REVIEW OF REPORTS BY GIBBS AND COX, INC., LOCKHEED MISSILE  
AND SPACE CORPORATION, M. ROSENBLATT AND SONS,  
ON 400 MWe COMMERCIAL OTEC PLANTS

Final Report

June 1979

JOHN J. McMULLEN ASSOCIATES, INC.  
One World Trade Center - Suite 3047  
New York, New York 10048

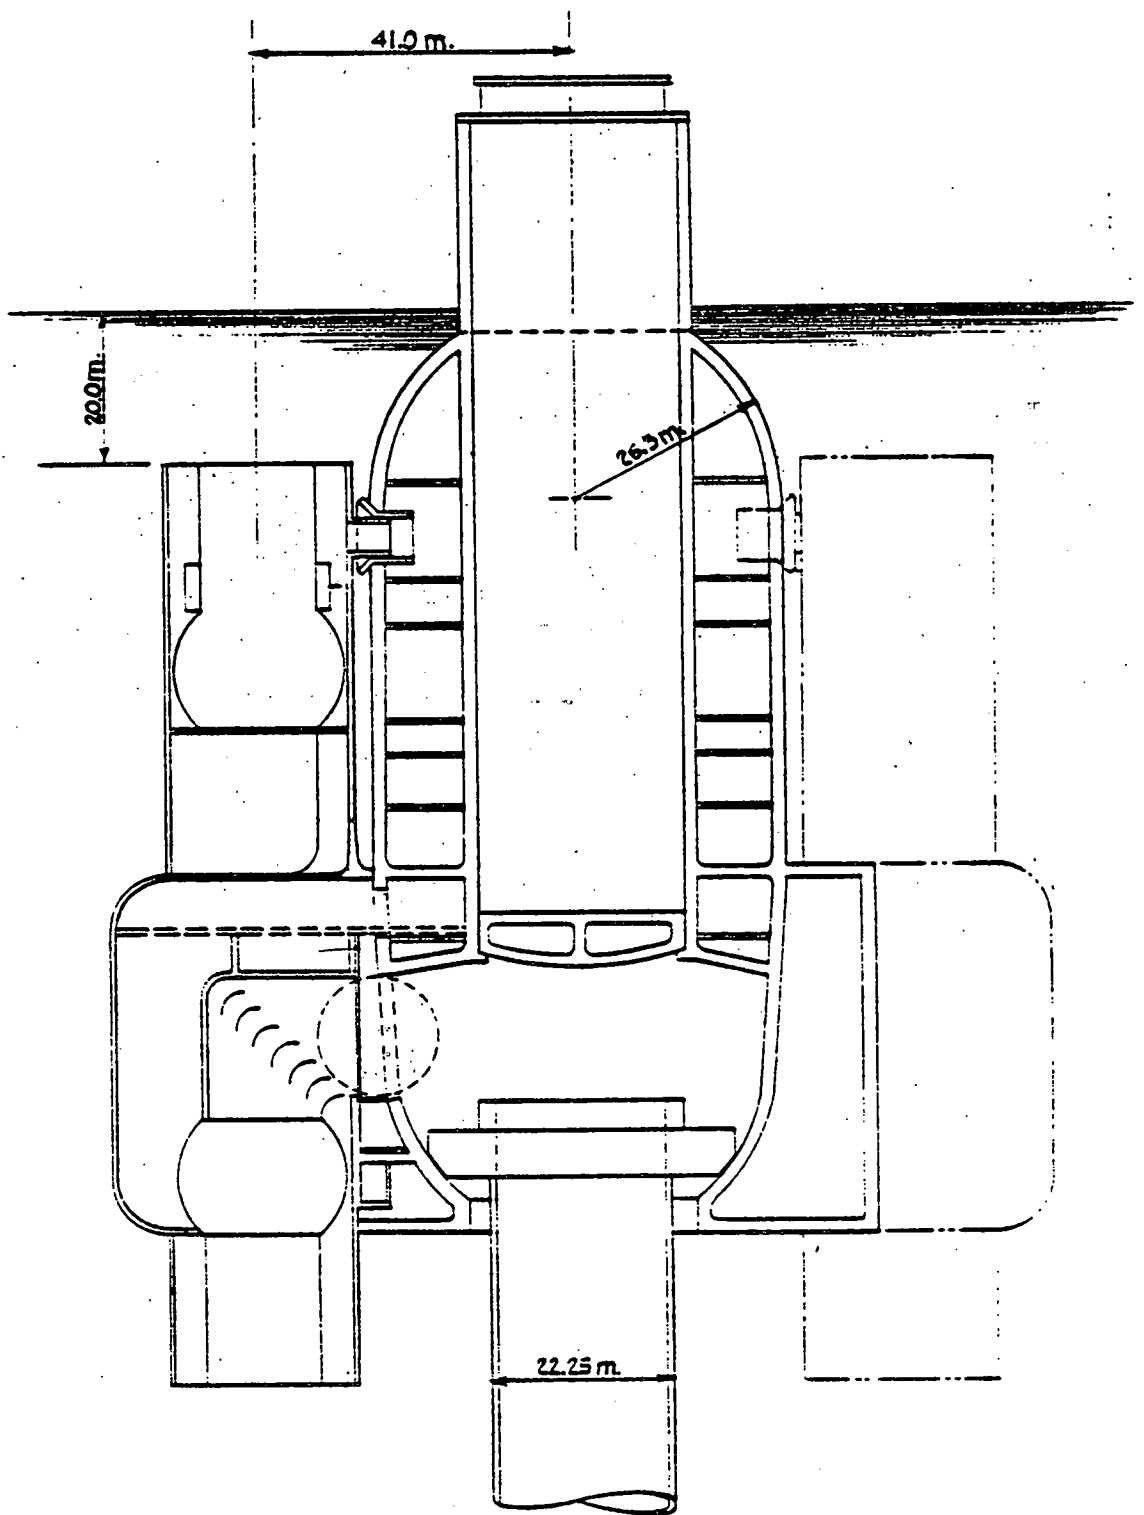
Figure 5.1 shows a spar concept modified to allow loading the CWP from the top. The diameter of the central core is increased from 36m to 59m. A trunked opening large enough for passage of the CPW is provided on the centerline. The increase in the weight of the structural concrete due to the revised spar dimensions has been estimated at 30,000 tons per platform. The resultant cost increase for an OTEC park was estimated to be in the order of \$100,000,000 after allowing for savings through elimination of the submersible barge and reduction in deployment time.

Top loading of the CWP is impractical in the case of the MR&S spar, short of a quasi total redesign of the spar.
